Parramatta Light Rail: Stage 1

Environmental Impact Statement Submission

23 October 2017

Figure 2.1: Walking distances from building EM at UWS Parramatta

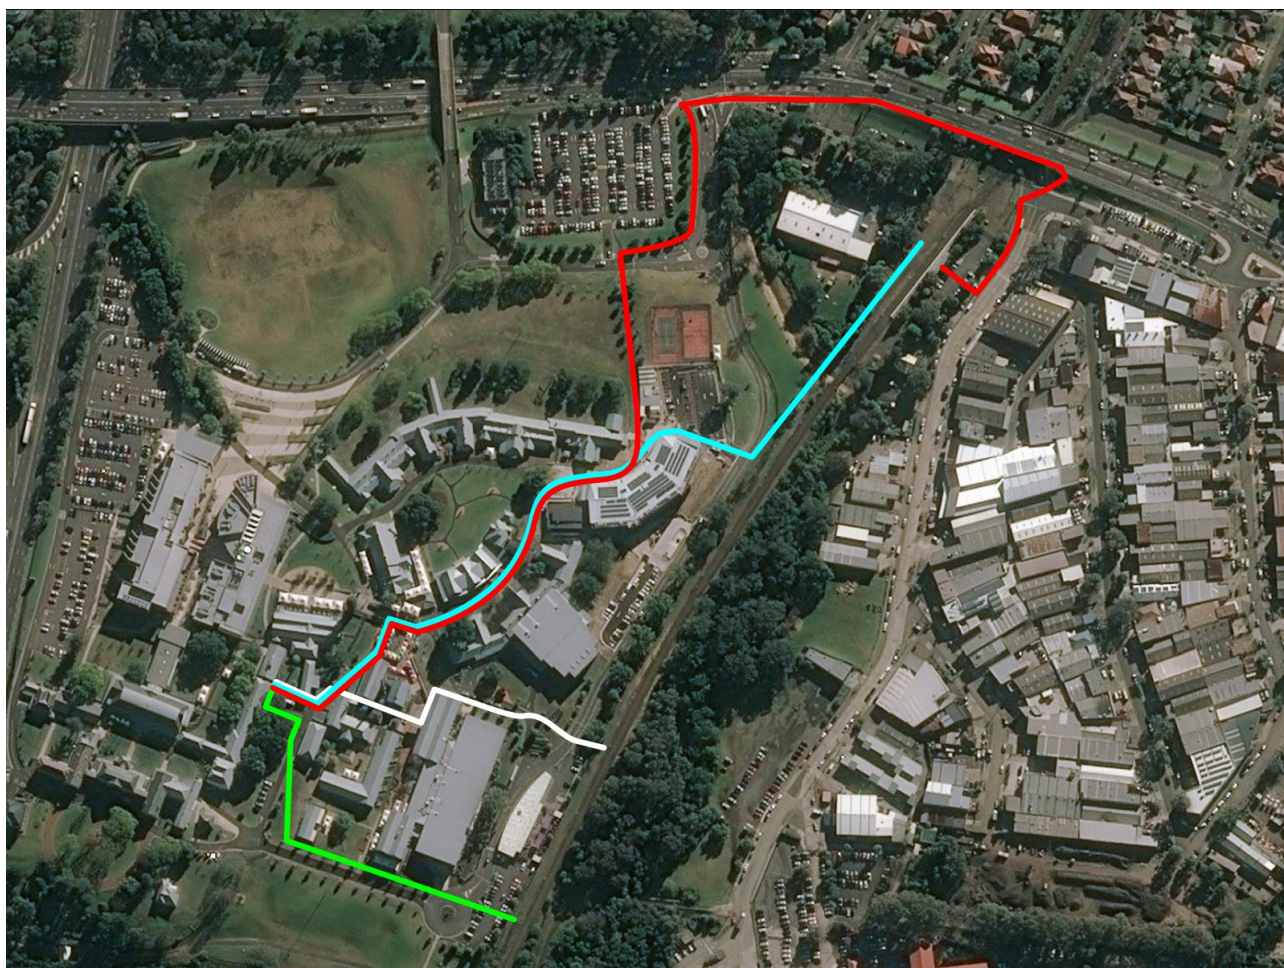
Figure 2.1 shows that the walking distance from buildings on the south side of the UWS Parramatta would be somewhat shorter if an additional stop at UWS Parramatta is built, saving up to five minutes in travel time (Table 2.1).

This is further compounded when compared to the current situation, where there is no direct link to the university from the stop. In this case, up to 10 minutes in travel time would be saved.

Because of the limited time savings provided by the additional stop, the Respondent agrees with the assessment conducted that the additional stop for UWS Parramatta is not necessary at the moment. This is provided that the proposed active transport link is built. If not, the significantly shorter walking distance would warrant building the additional stop.

That the design and construction of the light rail alignment ensures that a future stop at either the south-eastern or eastern ends of the campus will not be precluded.

That an additional stop should be provided for UWS Parramatta if the proposed active transport link is not built for any reason.
